Wollongong Local Planning Panel Assessment Report | 13 October 2020

WLPP No.	Item 3
DA No.	DA-2019/980
Proposal	Residential – demolition of existing building and construction of a dual occupancy and Subdivision - Strata title - two (2) lots
Property	82A Cliff Road, Wollongong
Applicant	Samuel Jones – c/- Architects Edmiston Jones
Responsible Team	Development Assessment and Certification - City Centre Major Development Team (RW)

ASSESSMENT REPORT AND RECOMMENDATION

Previous design with arched windows

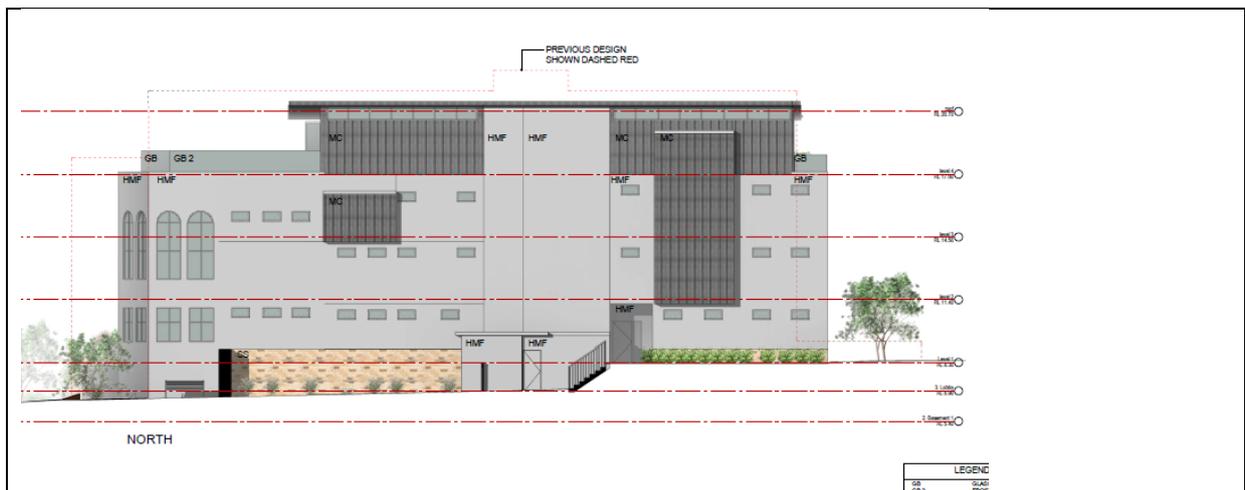
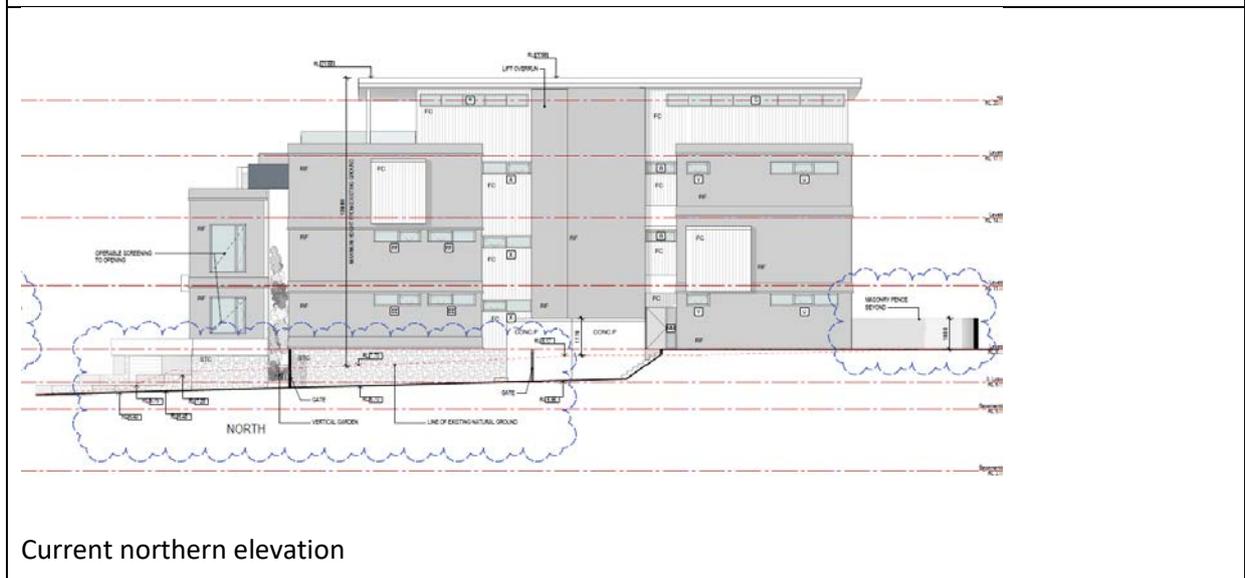
The previous design incorporated the use of arched windows and a defensive north elevation. The latest Panel comments noted that this expression may look out of place. The proposal has since been revised as shown below, including the removal of the arched windows and a more varied northern elevation, albeit retaining a defensive façade. The revised design is an acceptable design response to the Panel’s concerns on these specific issues.

Current design showing removal of arched windows

Current northern elevation

Figure 4: Contextual diagram comparing overshadowing impacts from existing building, proposed building, a three storey building and redevelopment of an amalgamated site with a 16m high residential flat building.

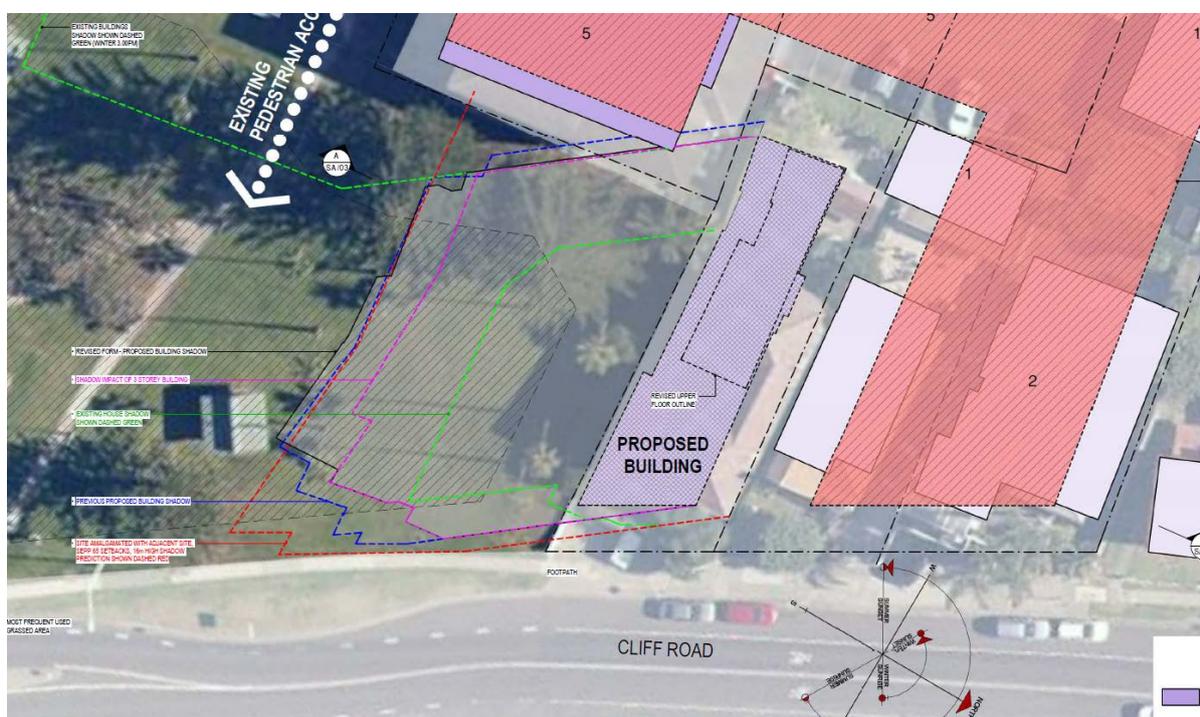
In Figure 4, the black solid line is the shadow cast by the proposed building and the red dotted line is the shadow cast by a 16m high residential flat building on an amalgamated site (i.e. a compliant development).

The impacts are comparable. Plans showing the overshadowing of a future compliant residential flat building on the adjoining two sites at 82 and 80A Cliff Rd would further inform an assessment of the likely future/cumulative overshadowing impacts on Osborne Park.

The non-compliant southern side setbacks add to the overshadowing and should be increased to at least 3m to minimise impacts on the public domain.

Figure 8: Site plan showing setbacks

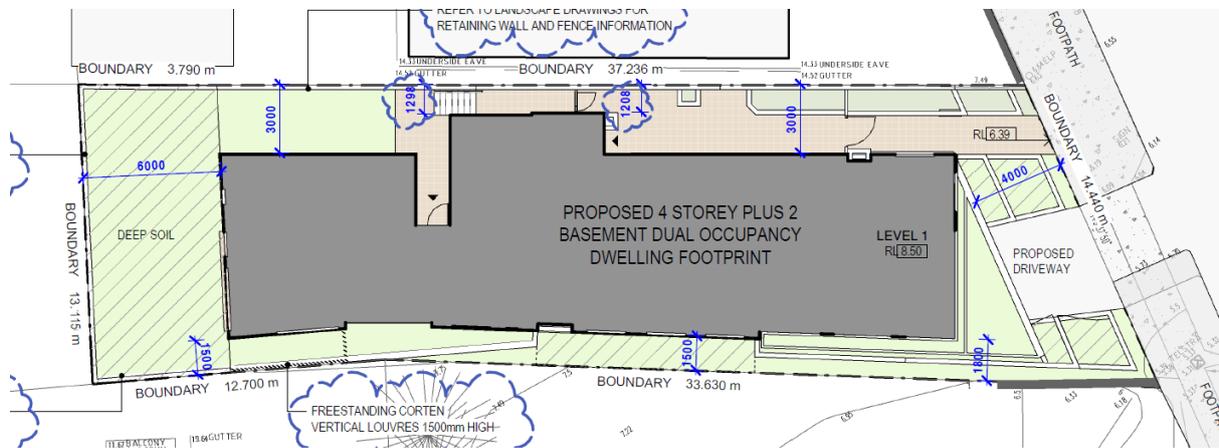
The minimal setbacks to the southern boundary do not provide enough separation between the four storey building and Osborne Park, resulting in a visually dominant built form. Given the park has heritage significance, the variation to the southern side setbacks is not supported. An increased setback allows an opportunity for greater separation, a more landscaped interface with the park which is considered a desirable outcome for the public domain.

Figure 9: Northern elevation

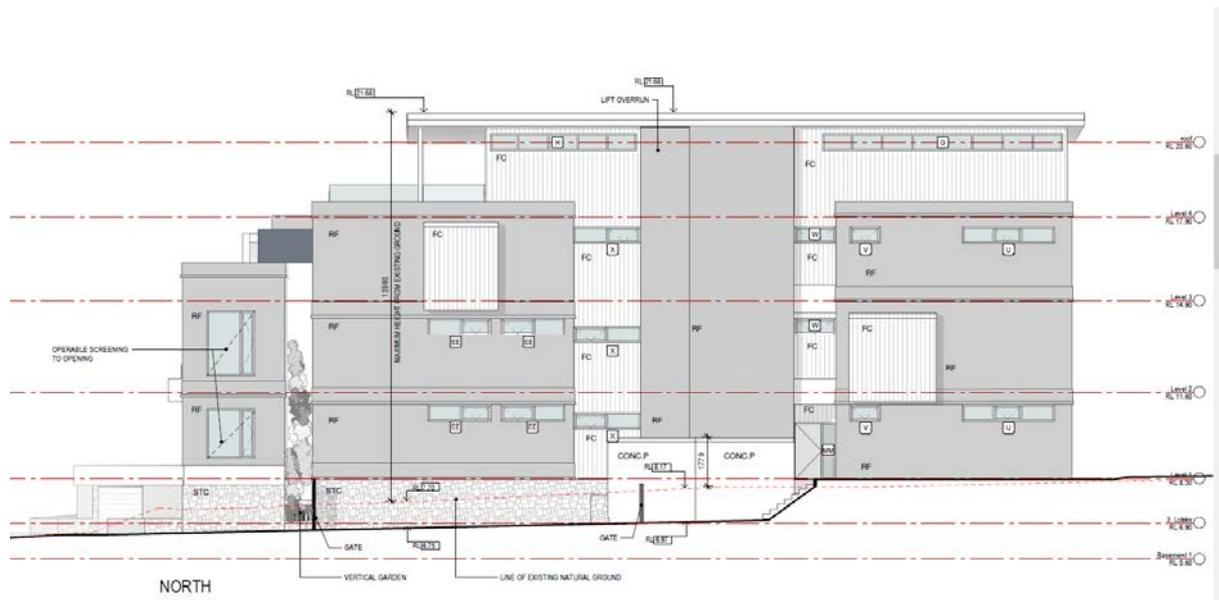
On the northern side, a defensive façade is proposed. A 3m setback to habitable rooms is provided incorporating highlight windows, as shown in elevation form below:

Encroachments into the 3m non-habitable setback are proposed, comprising:
